TAGGART-LOBLAWS SUBDIVISION

- *Overall Servicing Plan, Taggart-Loblaws Subdivision, Kanata West, Drawing OSP-1, Revision 5, April 27, 2012, Stantec Consulting Limited*
- *Didsbury Road Grading Plan, Taggart-Loblaws Subdivision, Kanata West, Drawing GP-1, Revision 5, April 27, 2012, Stantec Consulting Limited*

Figure No.
FIG-3

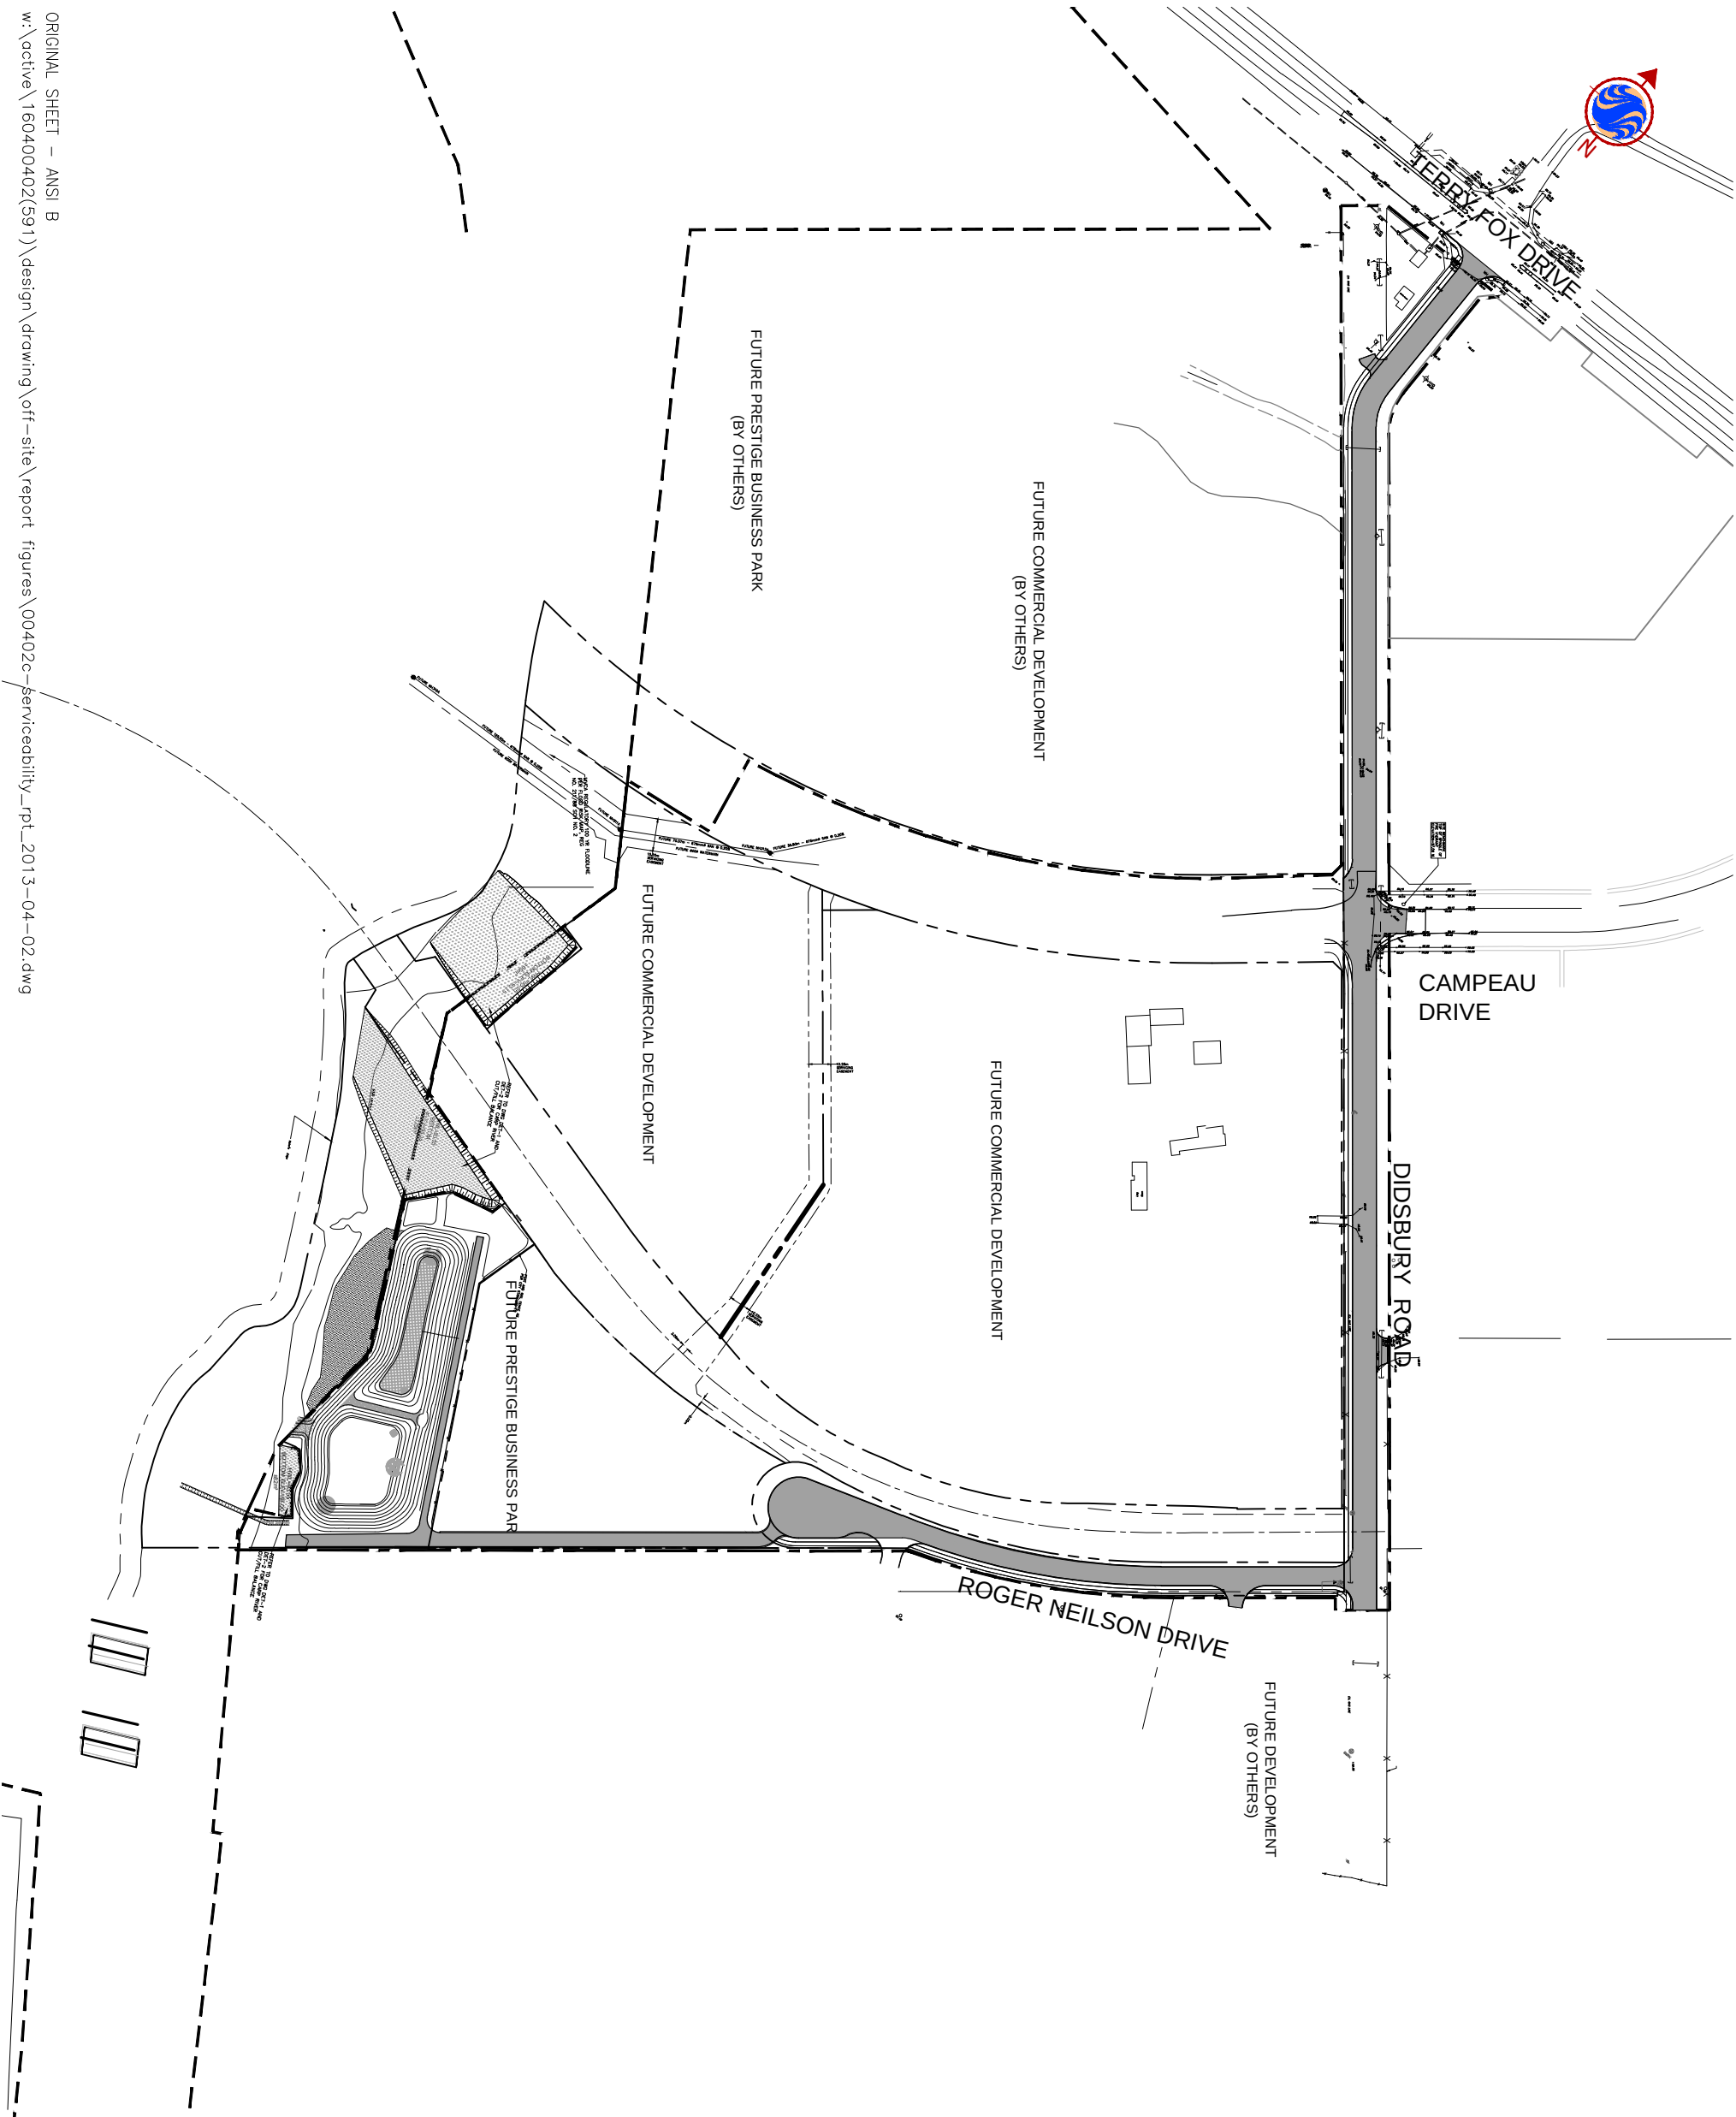
3. Sub-section 5.2 – Figure 3, reviewed in collaboration with the section does not clearly show existing and proposed water pipes.

3. Sub-section 5.2 – Figure 3, reviewed in collaboration with the section does not clearly show existing and proposed water pipes.

1. Sub-section 5.2 – Figure 3, Please provide different dash linetypes so that if the page is photocopied it will still be clear which are existing and which are proposed watermains.

1. Sub-section 5.2 – Figure 3, Please provide different dash linetypes so that if the page is photocopied it will still be clear which are existing and which are proposed watermain.

Response: Figure 3 has been re-printed in colour to better show the distinction between existing and proposed water pipes.
